UNITED STATES PATENT AND TRADEMARK OFFICE

APPLICATION NO.	FILING DATE	FIRST NAMED INVENTOR	ATTORNEY DOCKET NO.	CONFIRMATION NO.
10/663,069	09/16/2003	Sung-Tae Lee	084017.22223	2045

Office Action Summary

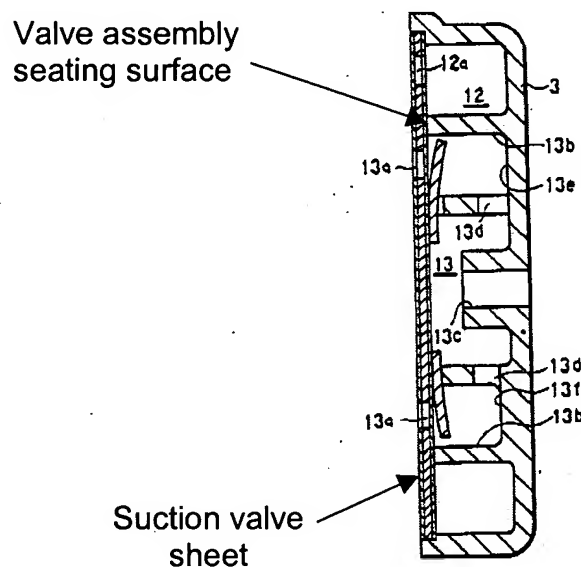
4. Claims 1-3 are rejected under 35 U.S.C. 102(b) as being anticipated by Suzuki et al (4,930,995). Suzuki et al. teach a cylinder block 1 having a cylinder 1a in which a piston 14 reciprocates; a rear housing 3 (corresponding to the claimed cylinder head) connected to the cylinder block, the rear housing defining an inlet hole 12 and being divided by a partition (unnumbered, but clearly illustrated in Figure 2c) into a first (13) and a second discharge chamber (generally described as element 13b and clearly illustrated in Figure 2c) that serve as an outlet path; a valve assembly (unnumbered, but clearly illustrated in Figure 2c) formed between the cylinder block and the cylinder head, the valve assembly controlling refrigerant outlet flow and inlet flow to and from the cylinder. Suzuki et al. further teach a passage 13d (corresponding to the claimed at least one connecting hole) that connects the first and second discharge chambers. As illustrated in Figures 2b and 2c, the partition is cylindrical and the space inside being defined as the first discharge chamber, and the space outside being defined as the second discharge chamber; the first discharge chamber having a valve assembly seating surface (see accompanying illustration) and the partition is provided with an inlet path therein formed without connection to the first discharge chamber. Suzuki et al. teach a valve assembly having a valve plate having an inlet port 12a (corresponding to

the claimed suction port) for connecting the inlet hole and the cylinder in fluid communication; a exit port 13c (corresponding to the claimed discharge port) for connecting the cylinder and the first discharge chamber in fluid communication; a suction valve sheet (unnumbered but illustrated in the accompanying illustration) having a suction valve for opening and closing the inlet port 12a; a discharge valve sheet having a discharge valve for opening and closing the discharge port.
